THE MARYLAND-NATIONAL CAPITAL PARK AND PLANNING COMMISSION

**MEMORANDUM**

**REVIEW TYPE:** Mandatory Referral  
**APPLYING FOR:** Modernization of Kensington-Parkwood Elementary School

**APPLICANT:** Montgomery County Public Schools (MCPS)  
**CASE NUMBER:** 02502-MCPS-1  
**REVIEW BASIS:** Article 28, Section 7-112 of the Annotated Code of Maryland  
**ZONE:** R-60  
**LOCATION:** 4710 Saul Road, Kensington, Maryland 20895  
**MASTER PLAN:** 1989 Master Plan for the Communities of Kensington-Wheaton

SITE PLAN

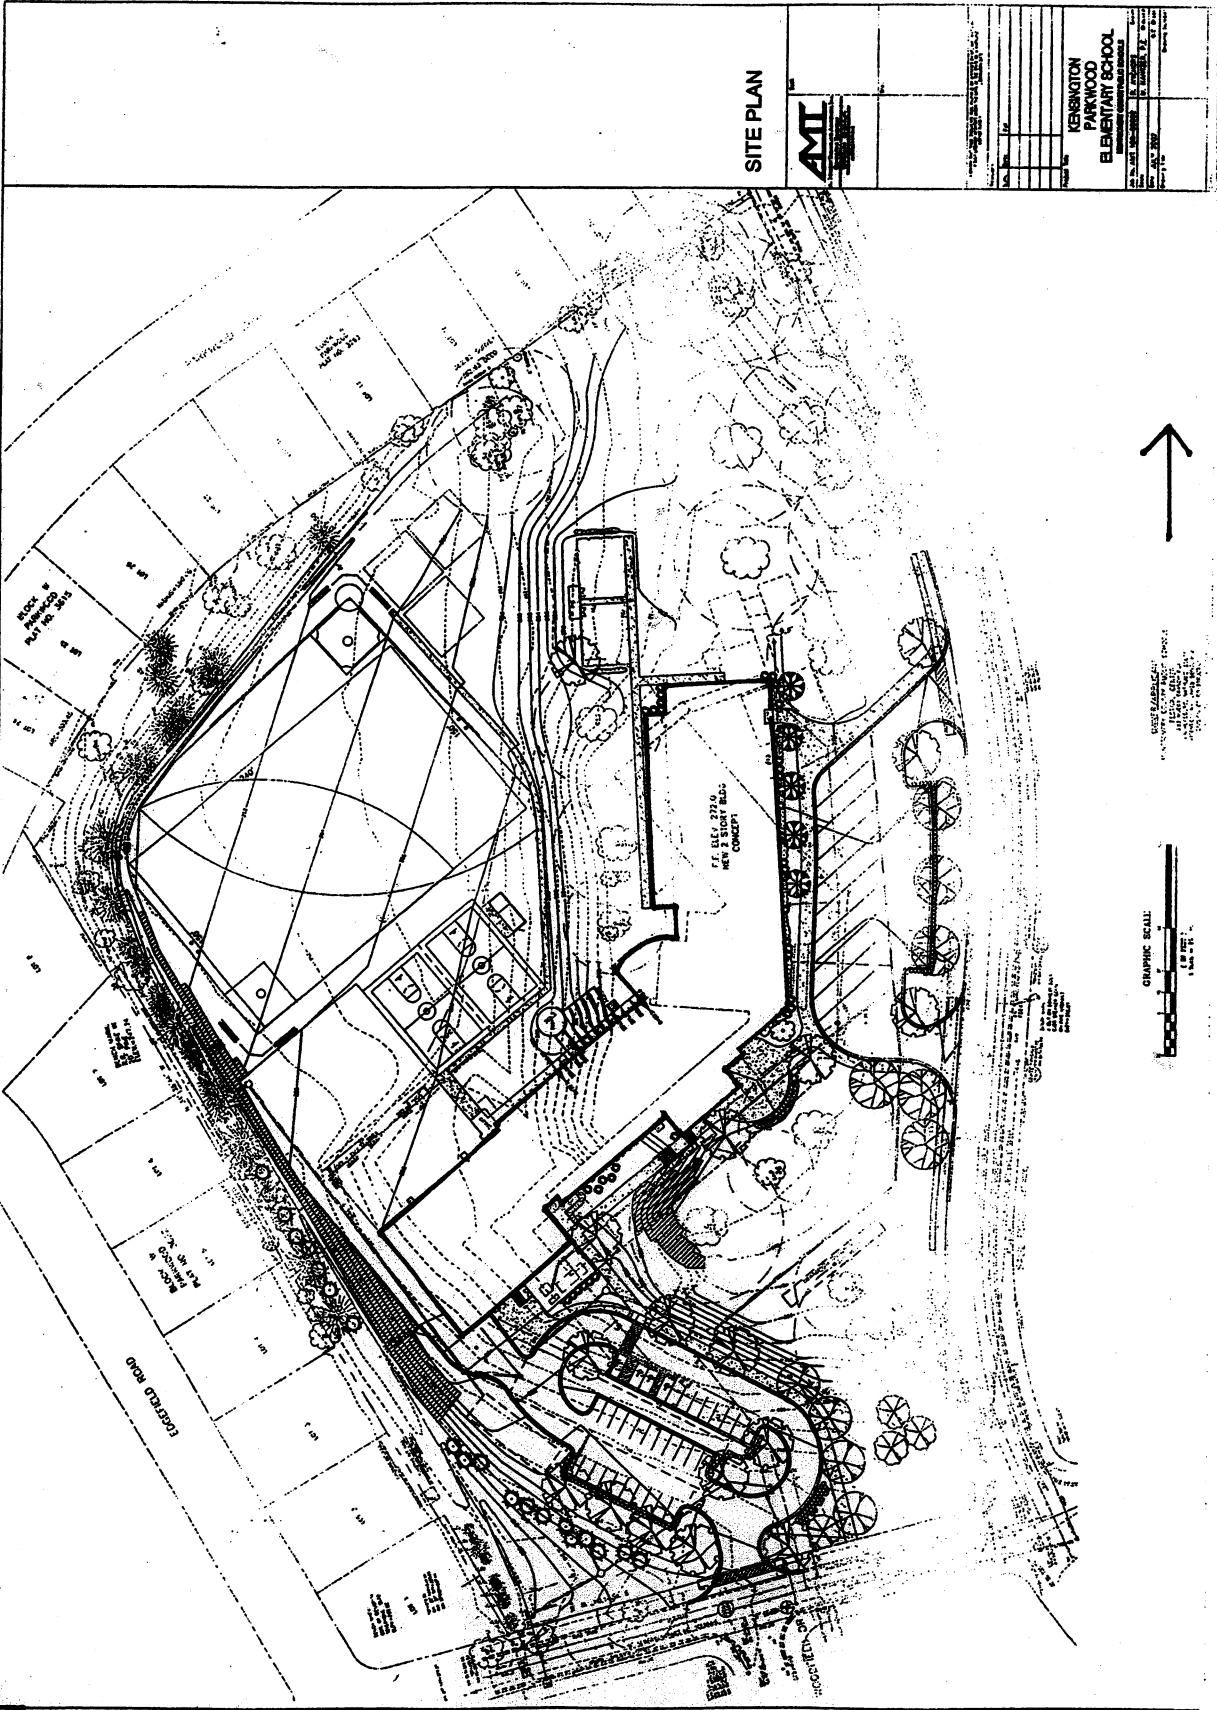
1. Any proposed additions to structures or parking should be the subject of further analysis through the Mandatory Referral process;
2. Replace five street trees removed from the public right-of-way with shade trees; species and size to be reviewed by staff of the M-NCPPC;
3. Reduce the radius of the western curb of the Franklin Road access to save an additional street tree; trucks are to exit east up Franklin Road;
4. Provide a description and specifications of the sound wall to buffer noise from the loading and servicing area; and
5. The revised plan is in compliance with Chapter 22a of the Montgomery County Code, the Forest Conservation Law.

Environmental staff believes the plan submitted showing a two story building and a relocated parking lot fulfills the Planning Board request to preserve a grove of five specimen trees on the north side of the site. The resubmitted plan shows one of the specimen trees removed at the time of construction. The arrangement of the five specimen trees forms an open space that we believe has considerable intrinsic value, value as an educational tool, value as a recreational area, and value in promoting energy reduction for the school. A one story building wing would destroy two, possibly three, of the five specimen trees and the landscape space formed by them. The two largest trees in the stand would be removed with the one story building option reducing the grove by half its size. We believe every effort should be made to preserve the grove and save all five specimen trees by using the two story building option.

- The proposed drop-off/parking scheme with the access on Franklin Street allows almost three times as much queueing capacity and more parking spaces than it appears a similar area would located between the bus loop and Franklin Street off Saul Road.
- As discussed previously, we will allow a tighter radius (15') on the northwest corner of the proposed driveway on Franklin Street, if it will save an additional existing street tree.
